CITY OF KELOWNA

MEMORANDUM

APPLICATION NO.: Z05-0014 & OCP05-0003

PURPOSE: To amend the Official Community Plan Future Land Use designation from Future Urban Reserve to Single/Two Unit Residential and Major Parks/Open Space and to rezone from the A1 – Agriculture 1 zone to the RU1h – Large Lot Housing (Hillside Area) & P3 – Parks and Open Space in order to facilitate a single dwelling housing subdivision of ~125.

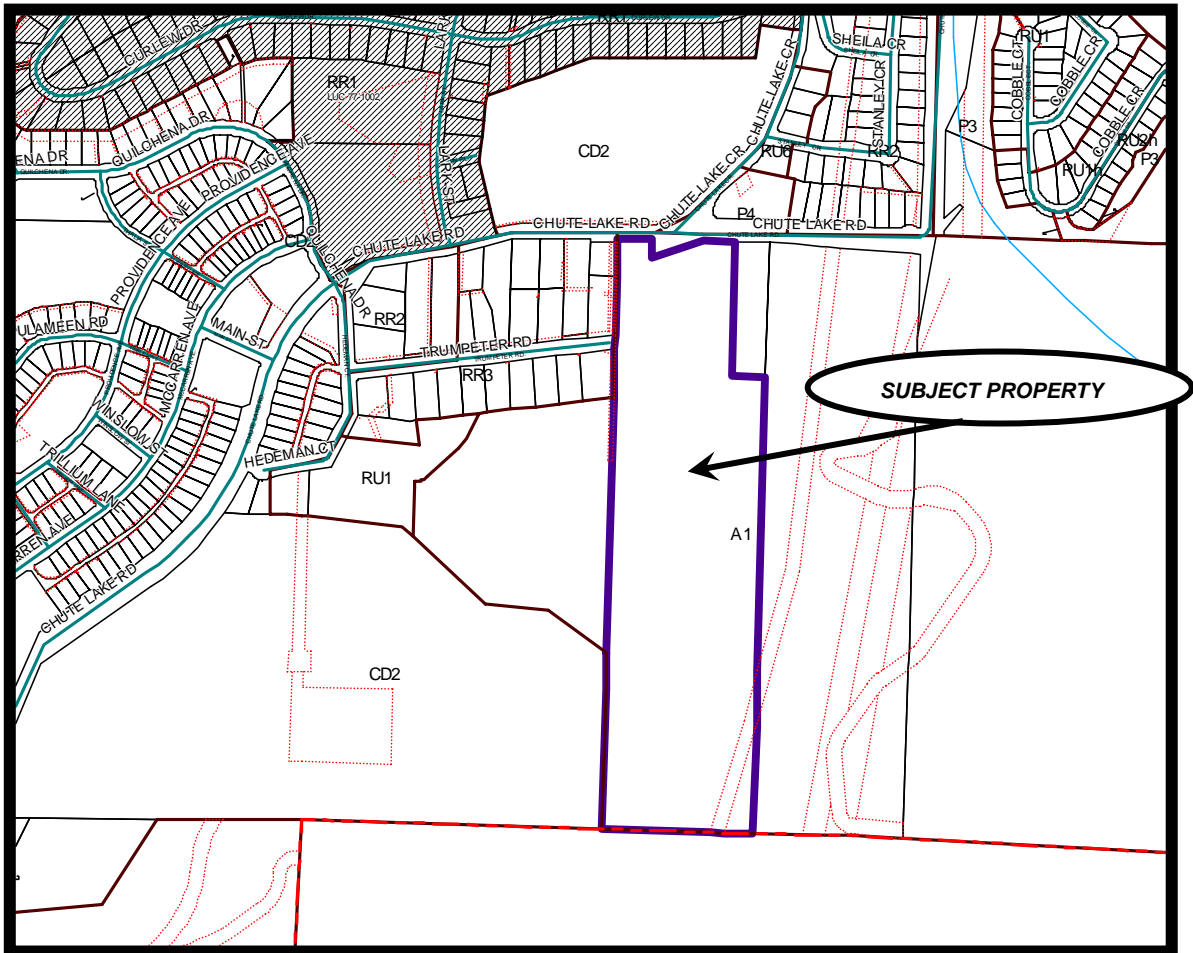
The preliminary plan of proposed subdivision provides the necessary road connectivity to the adjacent properties and also provides an open space corridor that will allow for a linear trail through the subject property and which will continue through the adjacent land to the east when it develops in the future. This Open Space Corridor will be zoned P3 – Parks and Open Space as part of the rezoning of this subject property.

- .1 Parks Staff require a linear park connection through the subject property as outlined in the OCP Map 14.2. The parkland corridor shown on the applicant's proposed subdivision plan lies in a natural valley with a seasonal creek corridor.
